BULLETIN #003

CONTRACT NO.: 15-015-CIP	DESIGNER: EMH&T
PROJECT NAME: John Shields Parkway, Phase 2	PROJECT MANAGER: Mandy Bishop, P.E., S.I. - GPD
CONTRACTOR: Nickolas Savko and Sons, Inc.	
DATE: JUNE 14, 2016

EMH&T Revision 4 – Revises changes made to the Columbus Industrial Entrance and Parking Lot Modifications.

JOHN SHIELDS PARKWAY PHASE 2

PLAN AND PROFILE - JOHN SHIELDS
Sta. 674+00 to Sta. 678+50

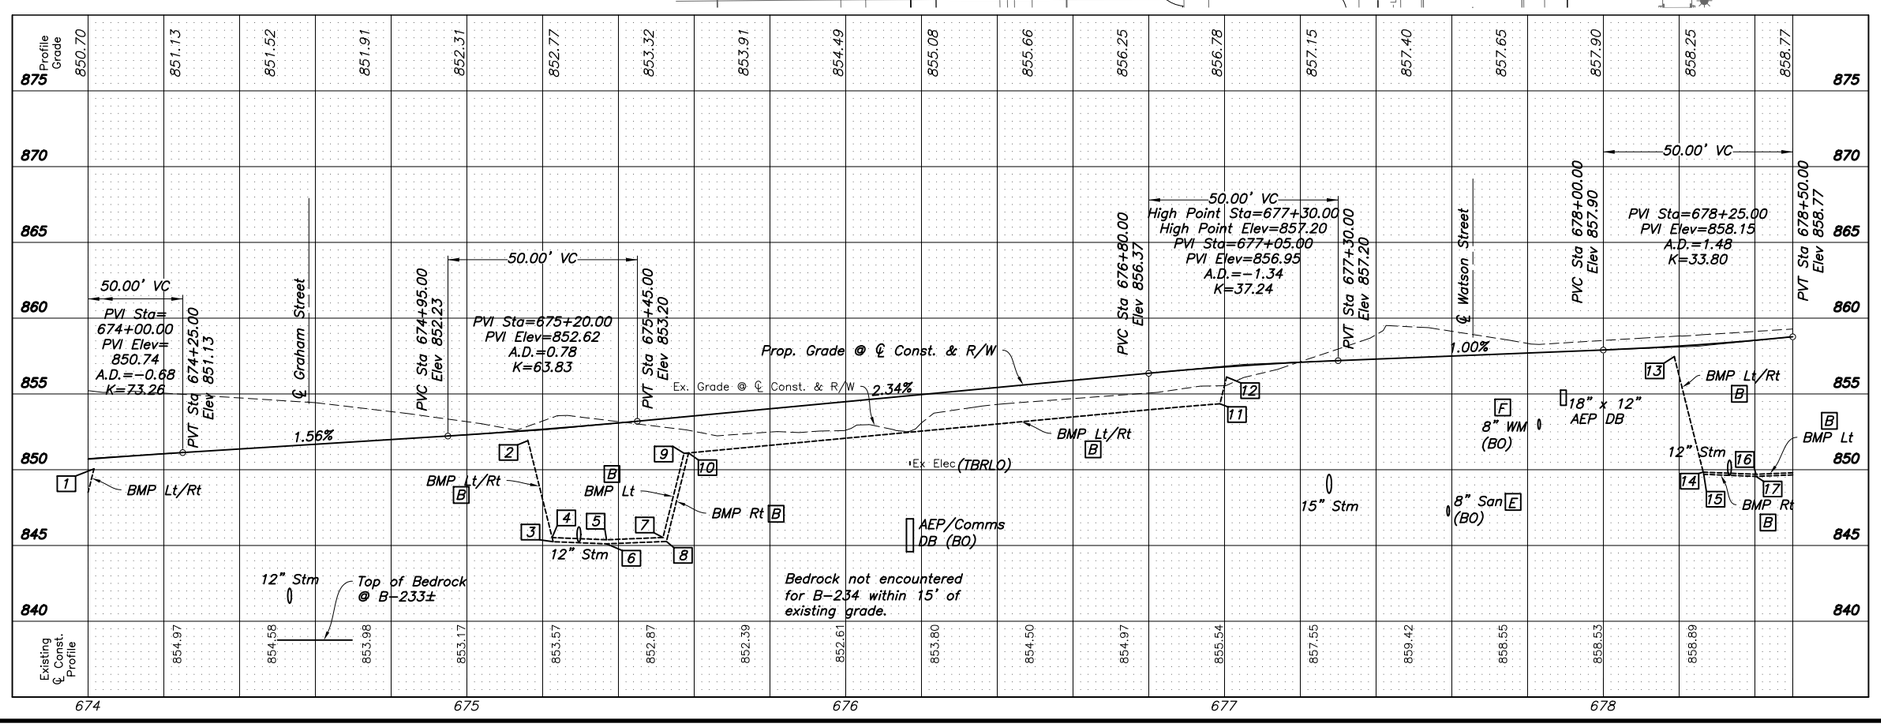
REVISION	DATE	DESCRIPTION
4	6-9-16	Revised Storm

DRIVE DETAILS

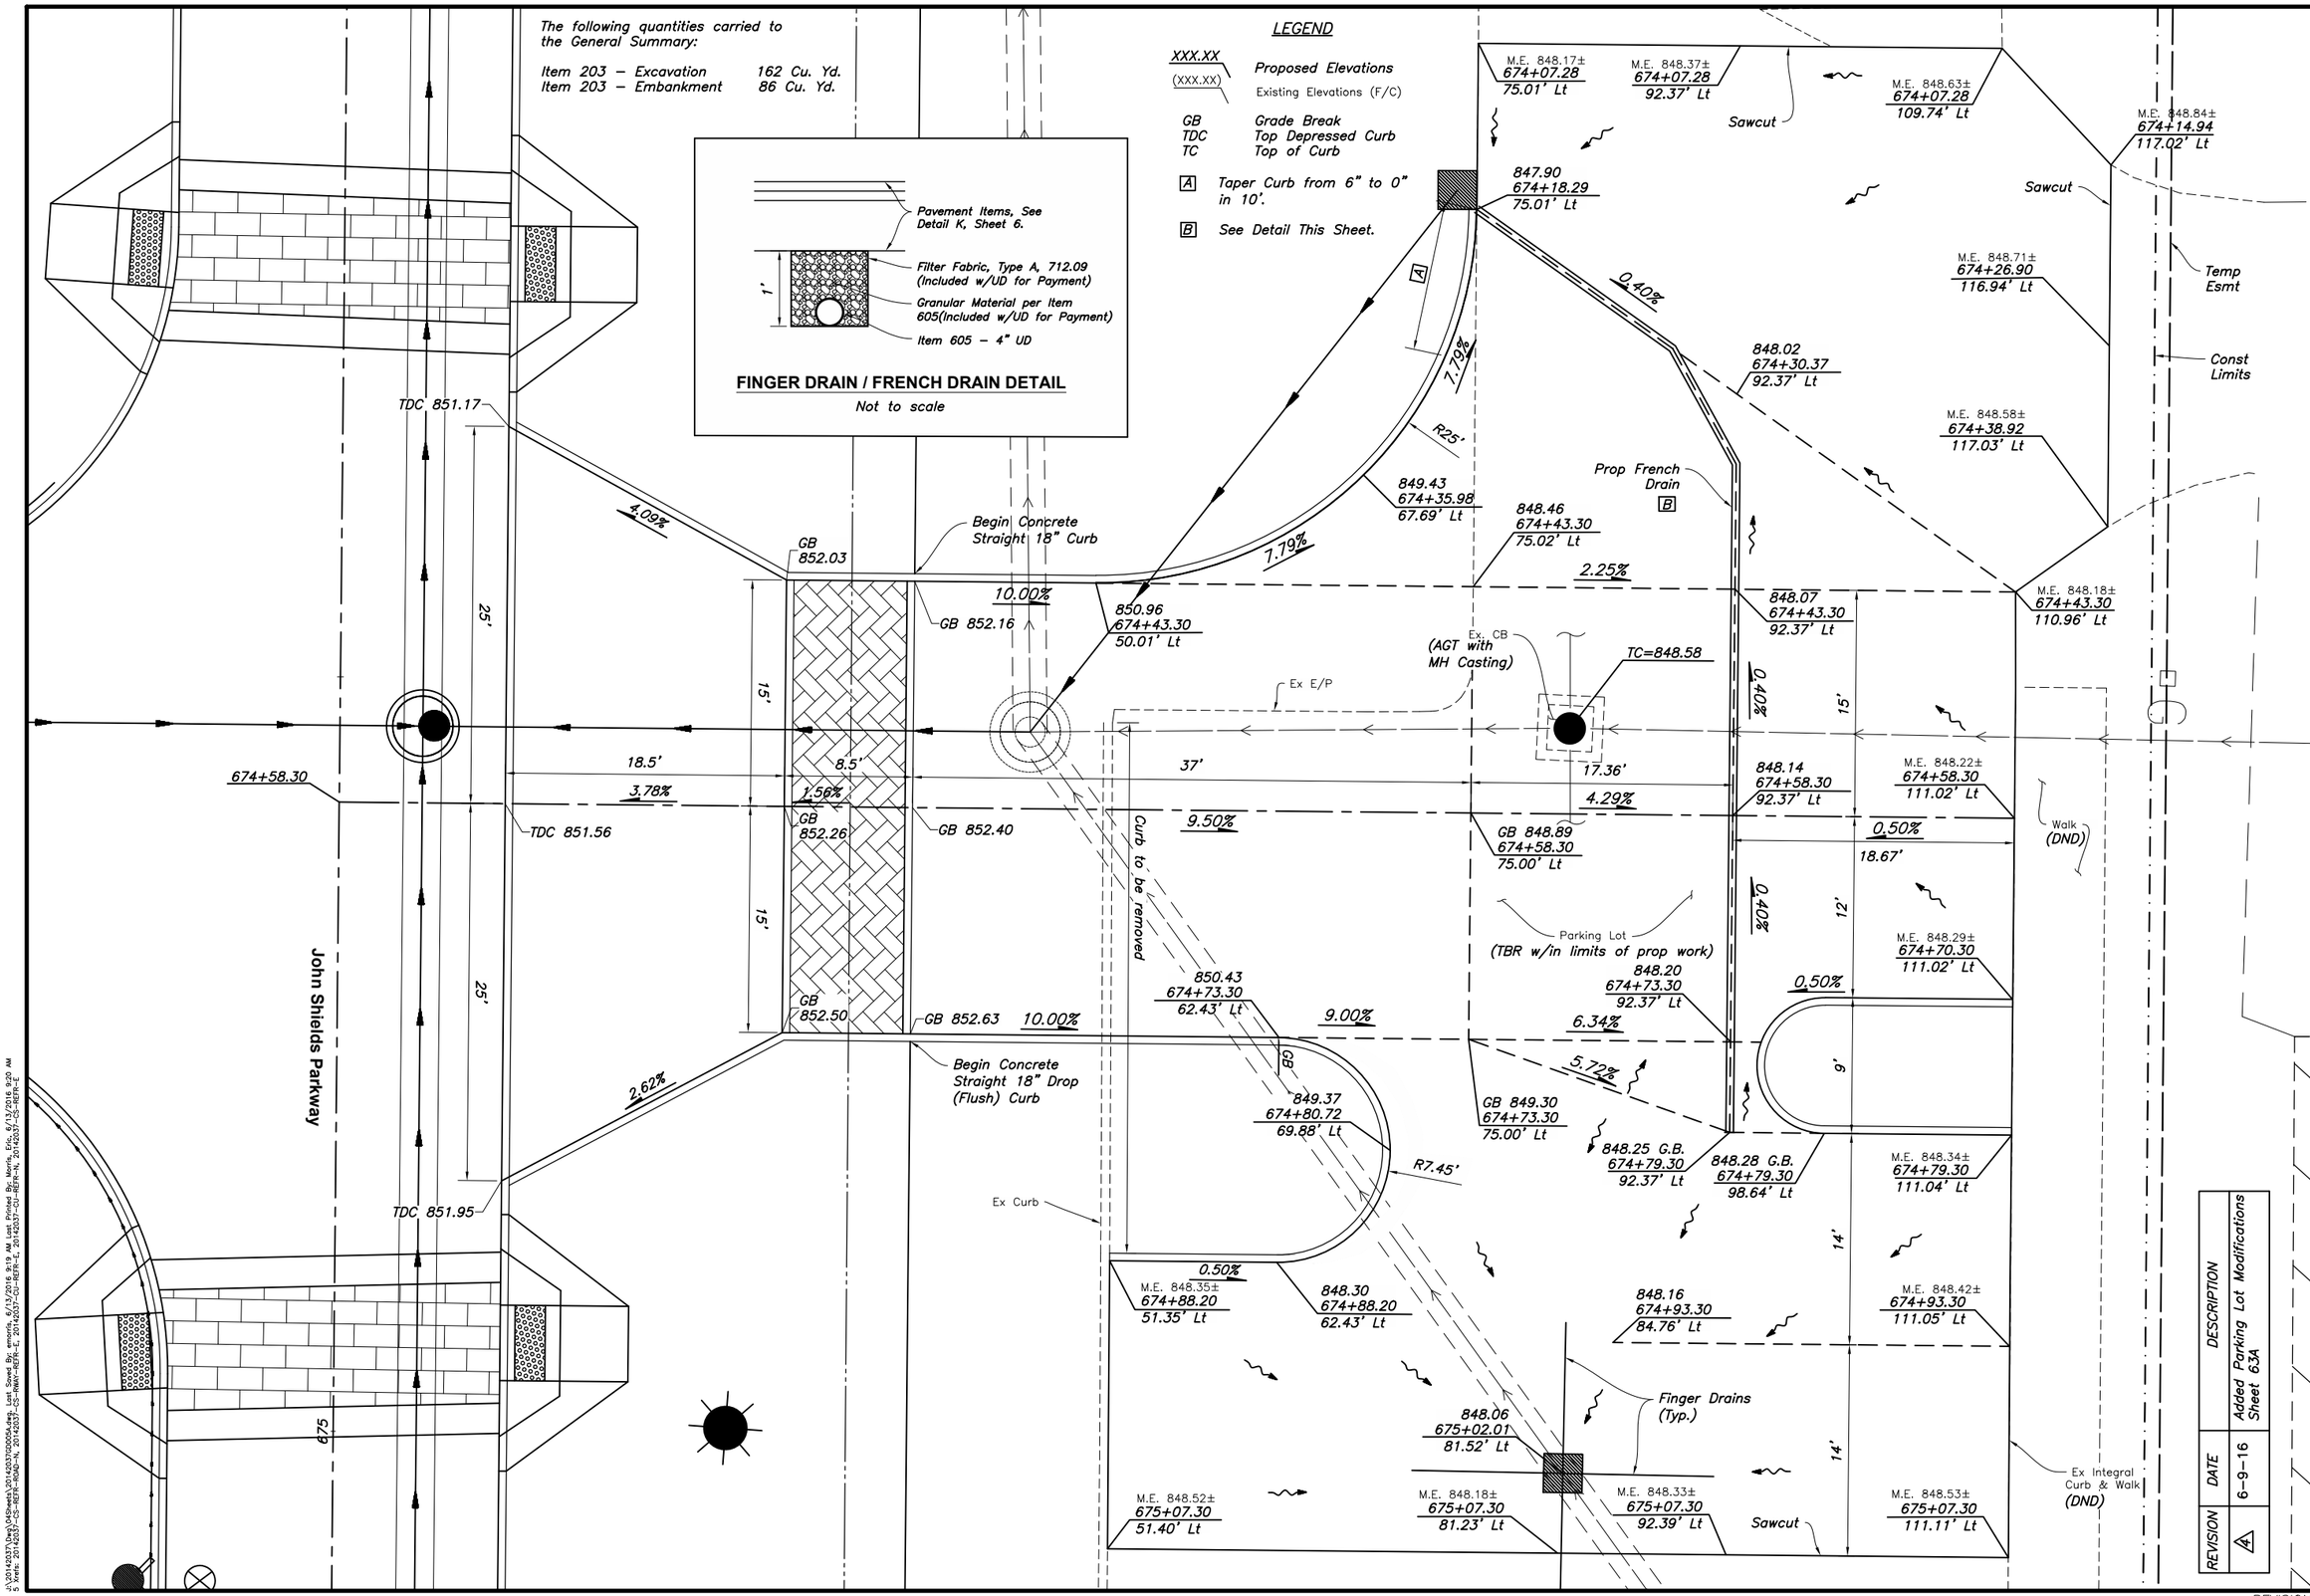
REVISION	DATE	DESCRIPTION
4	6-9-16	Added Parking Lot Modifications Sheet 63A

PARKING LOT MODIFICATIONS

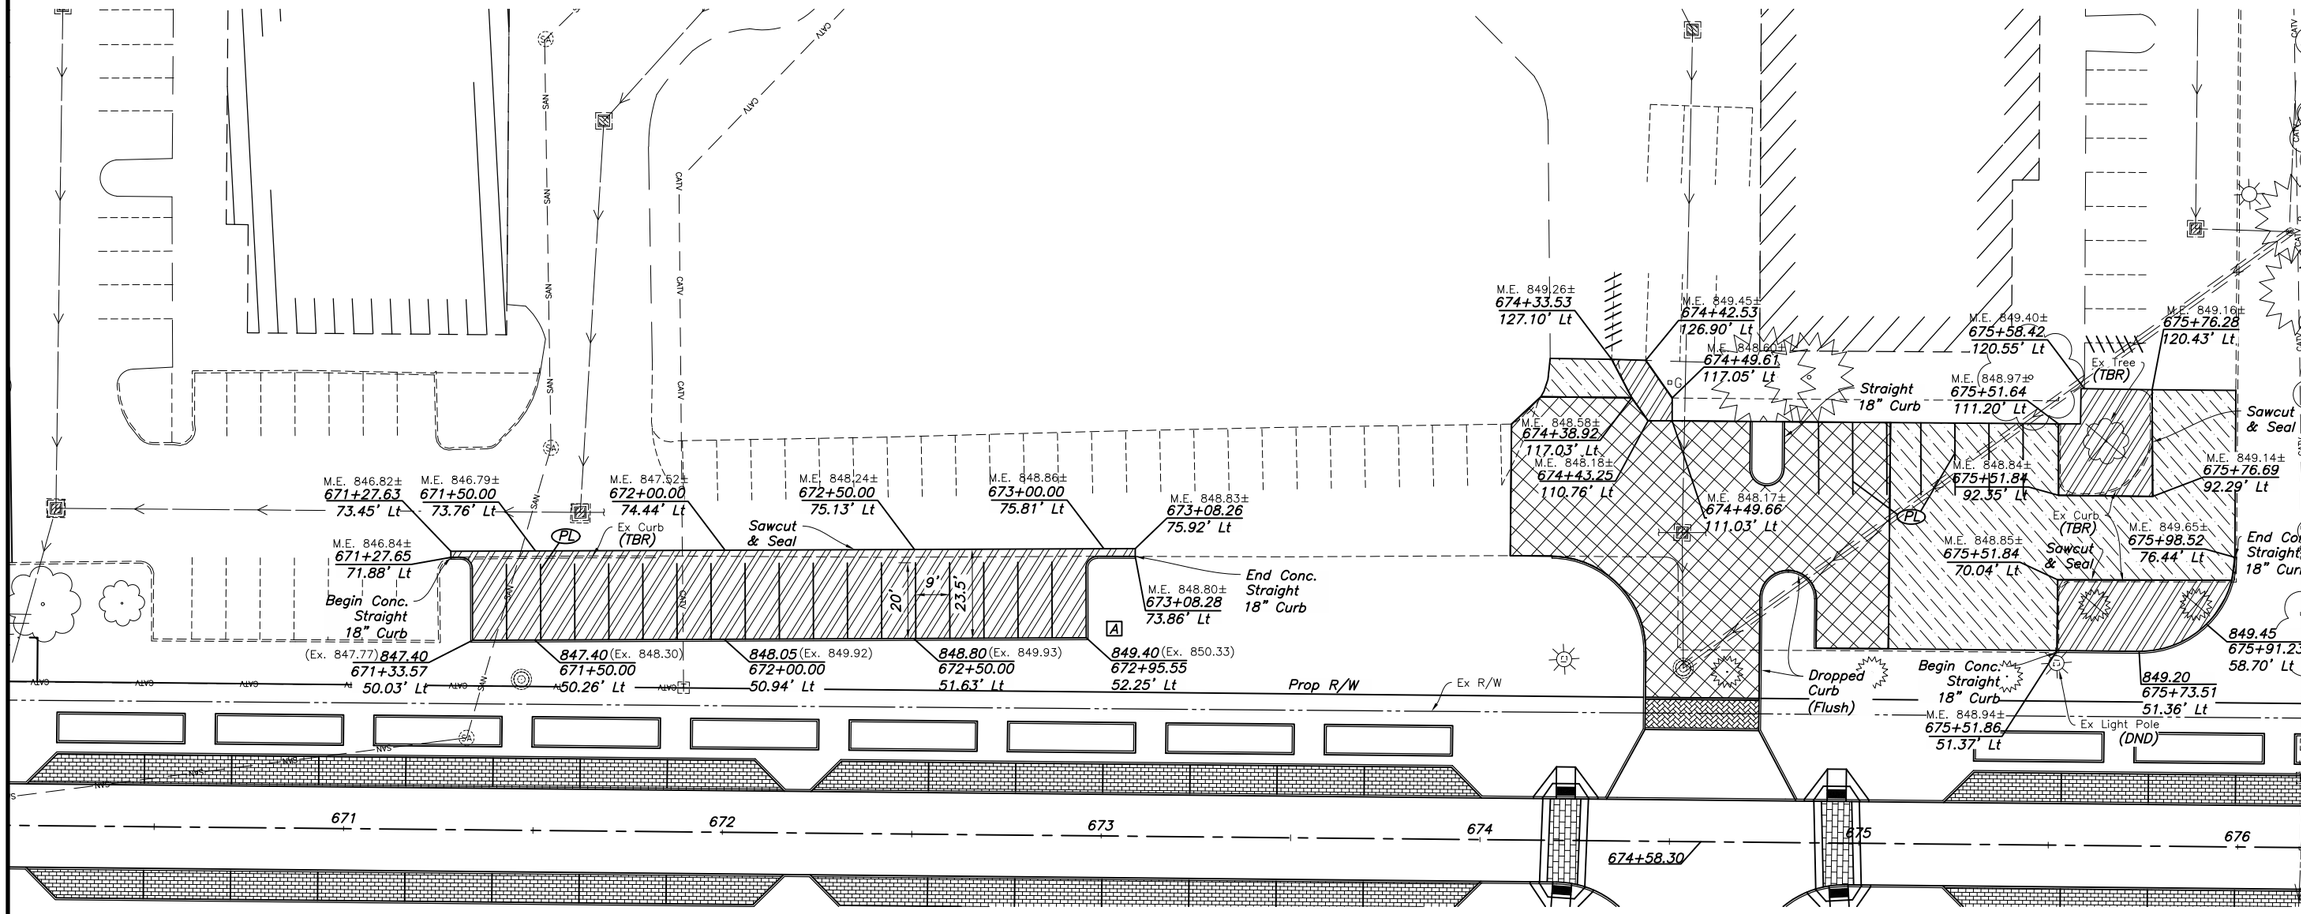
Quantities for Parking Lot Modifications not included in sheet 53:

REVISION	DATE	DESCRIPTION
4	6–9–16	Added Parking Lot Modifications Sheet 63B

CMSC Item	Description	Qty	Units
202	Curb Removed	256	Ft
203	Excavation	271	Cu. Yd.
203	Embankment	20	Cu. Yd.
204	Subgrade Compaction	598	Sq.Yd.
252	Full Depth Pavement Sawing	395	Ft
254	Pavement Plaining, 1.25"	501	Sq.Yd.
304	Aggregate Base	133	Cu. Yd.
407	NTSS– 1 HM Trackless Tack Coat For Intermediate Course	35	Gal
423	Crack Sealing, Type III	165	Lb
448	Asphalt Concrete Intermediate Course (Medium Traffic) PG64–22	30	Cu. Yd.
448	Asphalt Concrete Surface Course (Medium Traffic) PG64–22	39	Cu. Yd.
605	4" Pipe Underdrain (Finger Drain/French Drain, see sht. 63A)	111	Ft
609	Curb, Straight 18"	322	Ft
642	Parking Lot Stall Marking	480	Ft
642	Removal of Pavement Marking	40	Ft
*653	Topsoil, Furnished and Placed	12	Cu. Yd.
*659	Seeding and Mulching, As Per Plan	100	Sq. Yd.

STORM SEWER PROFILES

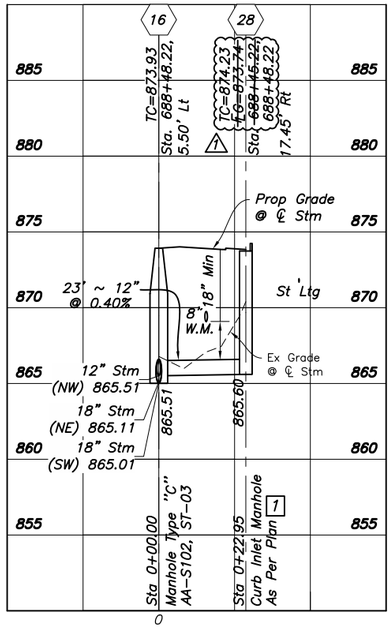
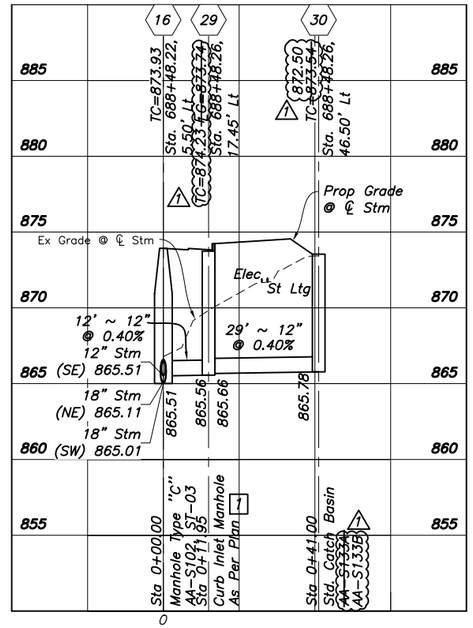
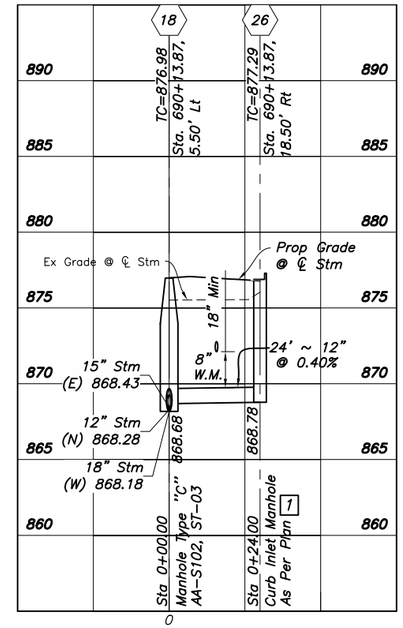
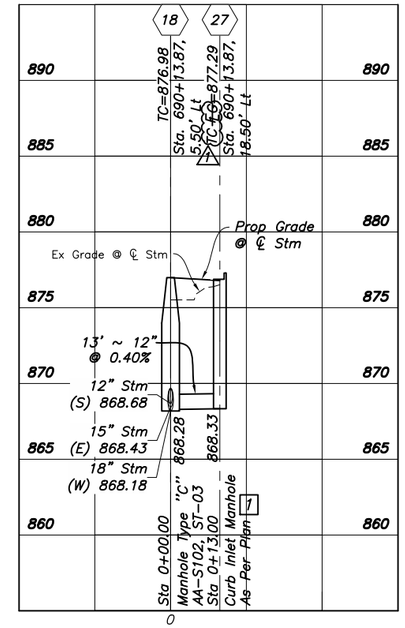
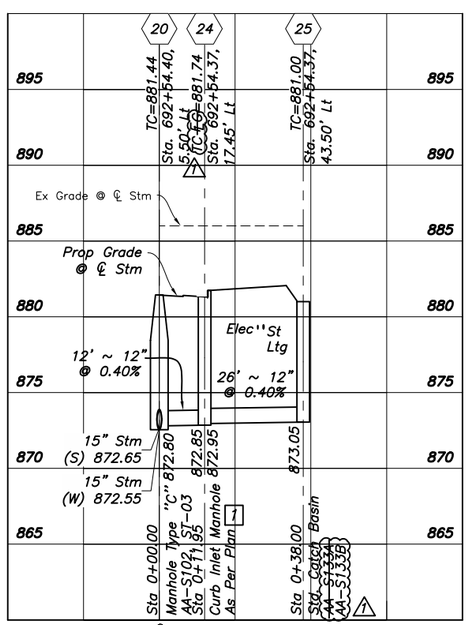
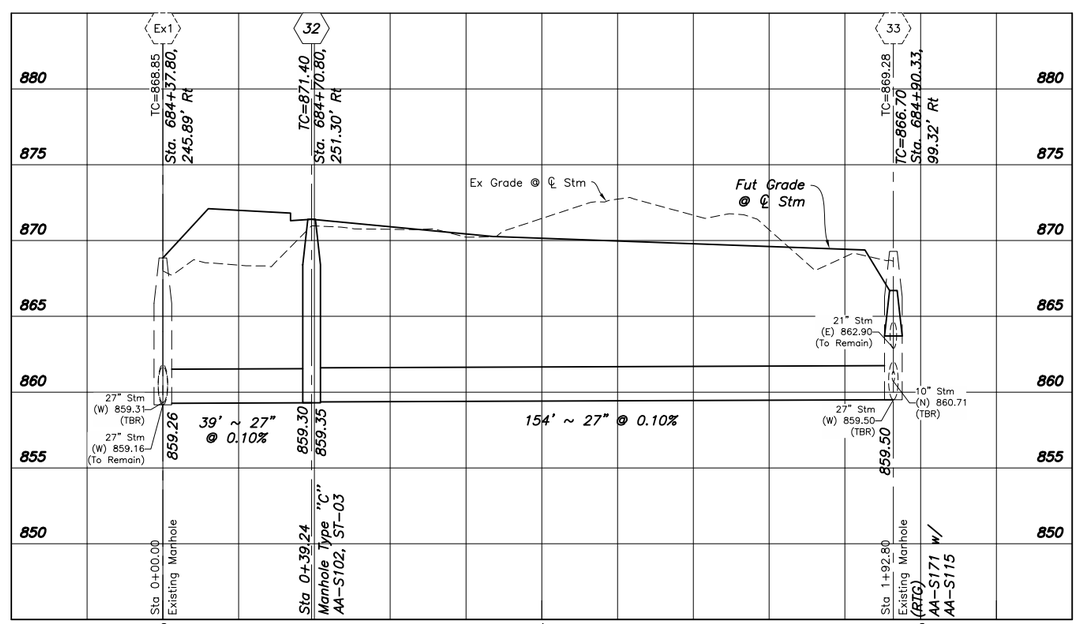
REVISION	DATE	DESCRIPTION
1	3–7–16	Revised Structure TC Elevations Revised Structure Type Revised Structure Sta./Offset
4	6–9–16	Revised Profile

Structure 53 (AA–S133B) 1
Sta. ~~674+93.30, 84.76' Lt.~~ 675+02.01, 81.52' Lt.
TC = ~~848.16~~ 848.06
Inv. Ex. 24" CPP = 841.68±
